FA27955 - Ver. 3.0 - What are the significant differences between the old D2 series contactors and the current Tesys D series?

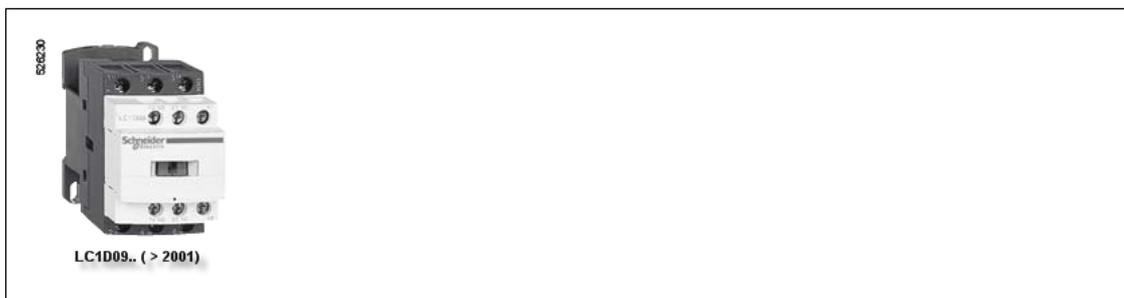
There is no longer an A2 coil connection on top of contactor. However, an adaptor LAD4BB3 is available to provide a top mount A2 connection.
